# Groundwater Application Review Summary Form

Application # G- 19353

# PUBLIC INTEREST REVIEW FOR GROUNDWATER APPLICATIONS

**A. GENERAL INFORMATION:** Applicant's Name: David Brown, Mitchell Ag. Investments, LLC  
 County: Wasco

Figure 1. Well Location Map

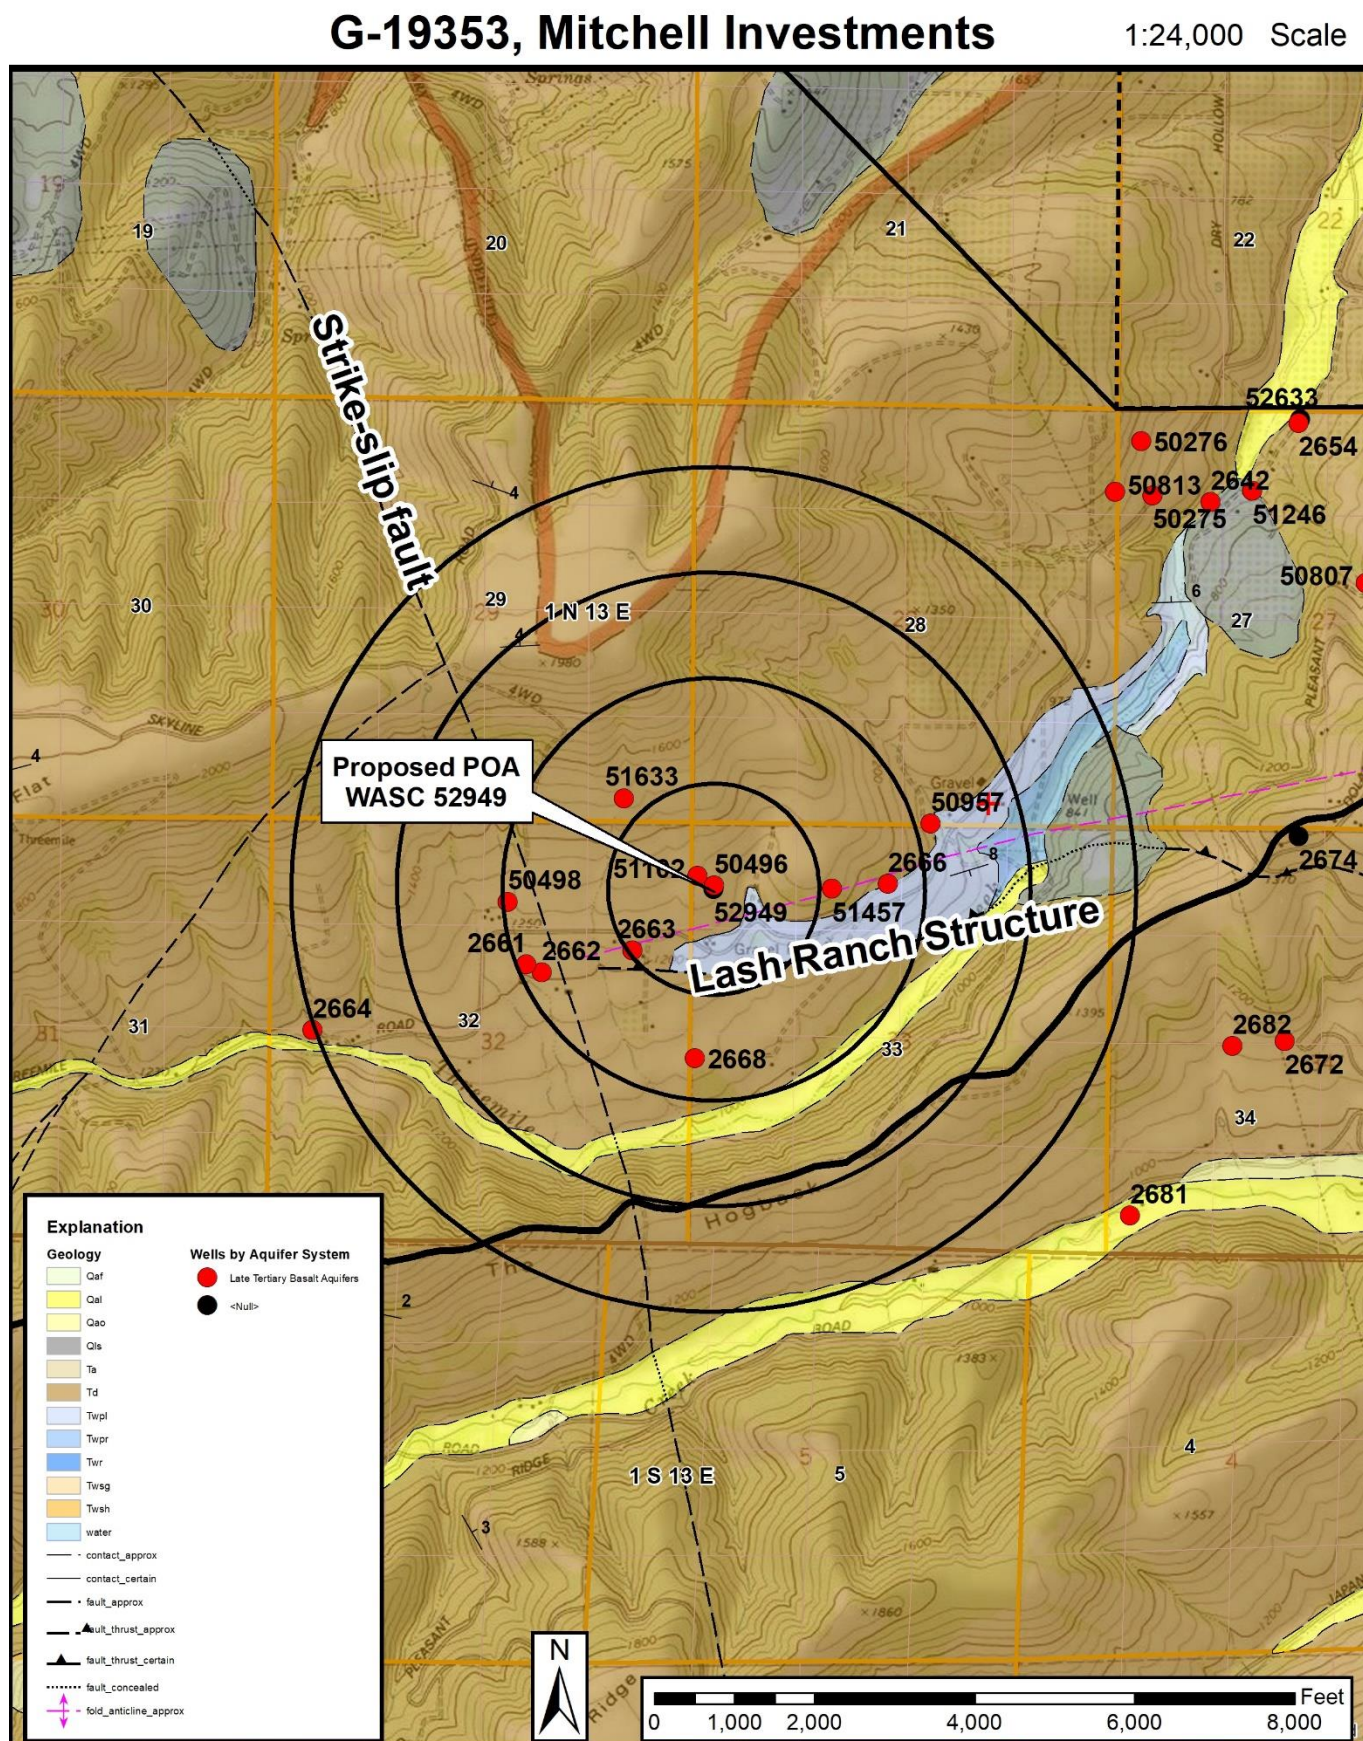
The proposed POA is located on the north limb of the Lash Ranch anticline/thrust fault, a south verging Yakima Fold structure associated with north-south compression related to oblique convergence of the Juan de Fuca and Gorda plates with the North American plate along the Cascadia subduction zone. The Lash Ranch structure appears to be a barrier to groundwater flow in the local aquifer system. In addition to the Lash Ranch structure, northwest trending, right lateral strike-slip faults also appear to restrict groundwater flow (see Figure 1 for locations).

**Figure 2. Water levels in wells south of Lash Ranch Anticline / Thrust Fault. WASC 51672 develops WBZs in the older (deeper) Grande Ronde Basalt while all other wells develop younger (shallower) Frenchman Springs units.**

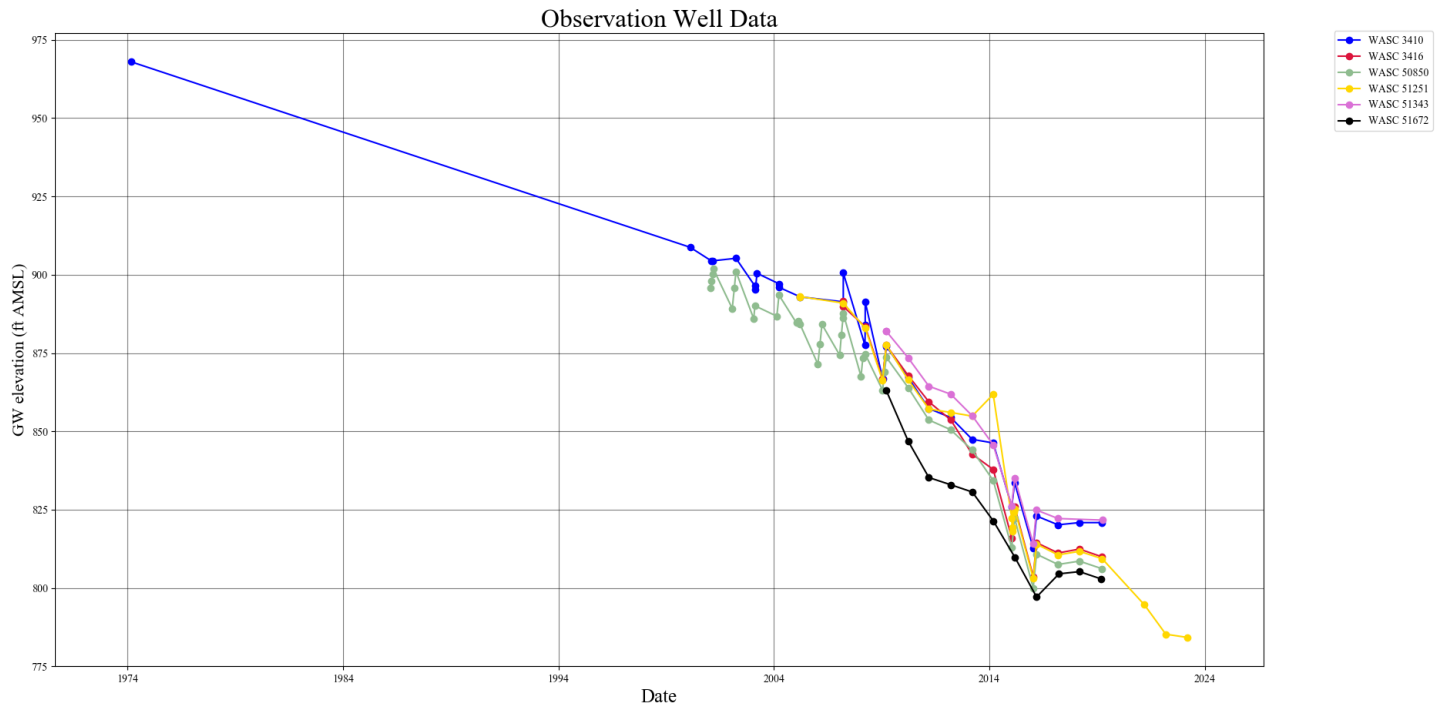
Water level elevations and trends in most wells south of the Lash Ranch structure are remarkably similar, regardless of stratigraphic unit of the WBZ (see Figure 2). Water level elevations in these wells have declined from approximately 900 feet above mean sea level (amsl) in early 2000s to less than 800 feet amsl in early 2020s. Wells WASC 3410, WASC 3416, WASC 50850, WASC 51251, and WASC 51343 are open to WBZs in Frenchman Springs units, while WASC 51672 produces from the upper Grande Ronde Basalt. The cause of water level declines is currently uncertain, commingling of WBZs with once distinct hydraulic heads may contribute. While water levels in most wells south of Lash Ranch structure fall into a narrow elevation range, levels in WASC 2668 do not. WASC 2668 is 870 feet deep, develops WBZs in the Grande Ronde Basalt and is located much closer to the axis of Lash Ranch structure. These factors suggest the well may develop WBZs that are not accessed by other wells south of Lash Ranch. Water levels in the well are relatively stable and are at an elevation of approximately 1100 feet amsl; nearly 300 feet higher than other wells south of Lash Ranch structure. In addition to water level elevations greater than 300 feet above those in other wells south of Lash Ranch, the water temperature in WASC 2668 is approximately 90°F. Elevated water level elevations suggest the Lash Ranch structure may act a barrier to groundwater flow as groundwater is dammed in front of the structure. Also, elevated water temperature suggests the Lash Ranch structure may be a deep-seated feature that is allowing vertical migration of heat near the well.

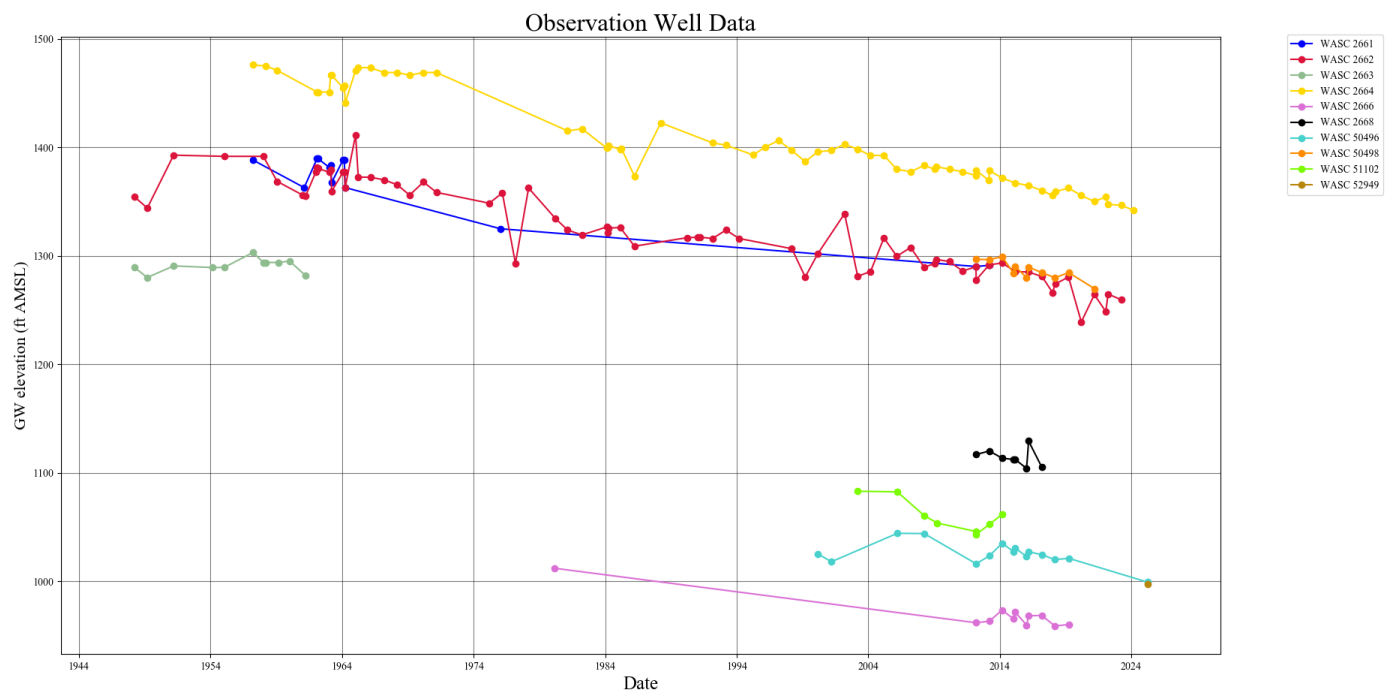
The proposed POA (WASC 52949) is located north of the Lash Ranch structure, within 400 feet of the anticlinal axis and within 1000 feet of the exposed thrust fault plane. Water level elevations in wells north of the structure display more variability than wells to the south (see Figure 3); some variability appears to be related to compartmentalization of WBZs across a northwest trending strike-slip fault in 1N/13E-32. Water level elevations are highest in wells west of the fault (WASC 2661, WASC 2662, WASC 50498) while water level elevations in wells east of the fault (WASC 2666, WASC 50496, WASC 51102, WASC 52949) are several hundred feet lower. The proposed POA is located adjacent to WASC 50496, a well in the group east of the strike-slip fault in 1N/13E-32.

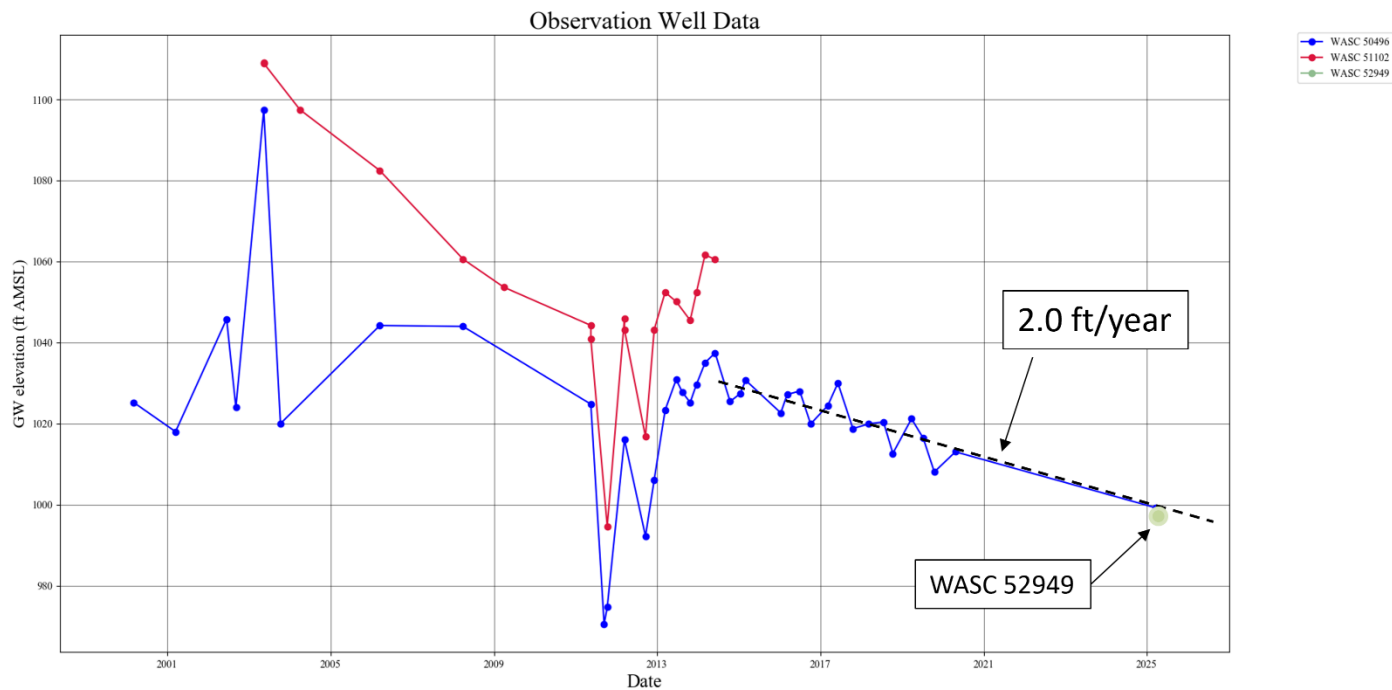
As discussed above, the proposed POA develops a WBZ in the Frenchman Springs member of the Wanapum basalt formation. Groundwater level data in the area is limited, however, the static water level in adjacent well WASC 50496 has declined 24 feet since 2013 (average rate of approximately 2.0 feet per year between 2013 and 2025 (Figure 4)).

Additionally, the static water level elevation in the proposed POA (WASC 52949) is within 2 feet of the water level elevation in WASC 50496, measured on the same day. The similarity in water level elevations suggest the wells produce from the same aquifer. Long-term water level decline indicates the aquifer is already over-appropriated and cannot support the new groundwater use proposed on this application.
